**Item No:** T1216 Item 13

**Subject:** LOCAL ROUTE 3 (LIVINGSTONE ROAD) - PUBLIC CONSULTATION  
REPORT

This is the final concept plan for improvements to Local Route 3 following public exhibition of the draft concept plan. 62% of the responses received did not support the concept plan. Based on the public exhibition feedback the concept plan has been amended. The main objection to the concept plan was the proposed removal of on-street parking on Livingstone Road. The final concept plan identifies a route along Livingstone Road from the Bankstown Line rail corridor to Marrickville Park to make bike riding safer, more comfortable and more convenient, and addresses the community concerns by significantly reducing impacts to on-street parking on Livingstone Road and proposing an overall increase in on-street parking spaces along the route. All community submissions have received a letter noting the changes made and the next steps. The concept was considered at the November joint LRAC meeting. This report recommends that the final concept plan be approved and detailed designs for the route be developed.

Figure 1: Revised typical cross-section on Livingstone Road with bike path and parking lanes.

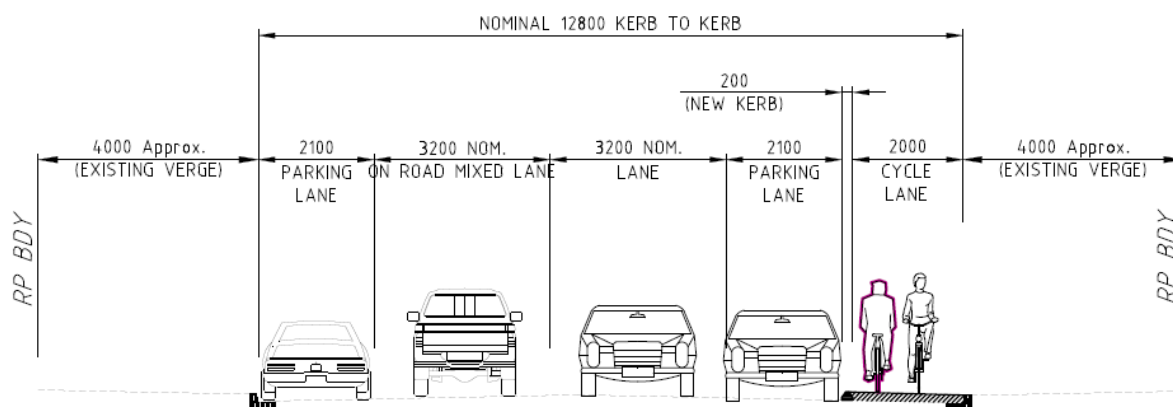
Other road configurations that could accommodate a bike path on Livingstone Road whilst also maintaining the existing parking lanes were then considered. A configuration agreed by RMS' Manager Network and Safety narrows the proposed bike path to 2.0m (from 2.4m), which then provides sufficient road width for both parking lanes to be maintained (Figure 1). The final concept plan has been modified to incorporate this proposed configuration. A 2.0m wide bike path is consistent with RMS and Austroads guidelines for local bicycle routes and allows room for two bicycles to safely pass one another. The proposed road configuration also meets Sydney Buses requirements for traffic lane widths (3.2m) and RMS standards for parking lane widths (2.1m), and provides a narrow median between parked cars and the bike path.

The revised two-way bike path design:

- supports Council objectives to make bike riding safer, easier and more convenient
- moves bike riders out of the 'car door zone' blind spot of people exiting parked cars;
- places bike riders on the non-driver side of parked cars, where doors are opened less frequently thus reducing the risk of potential conflict between bike riders and car doors;

- places bike riders travelling in the opposite direction nearest to parked cars, thus providing a good line of sight between car passengers and approaching bike riders to further reduce the risk of potential conflict;
- provides a defined space for bike riders to travel out of the traffic lanes,
- provides a safe bicycle facility on Livingstone Road whilst addressing community concerns about on-street parking. The new configuration results in only localised removal of on-street parking along Livingstone Road, with new parking spaces proposed to mitigate impacts of any removal of parking where feasible. On Livingstone Road a net increase of 1 parking space is proposed between the Bankstown Line rail bridge and Marrickville Park (comprising 8 spaces removed and 9 new spaces gained), down from 121 spaces proposed to be removed in the draft concept plan.
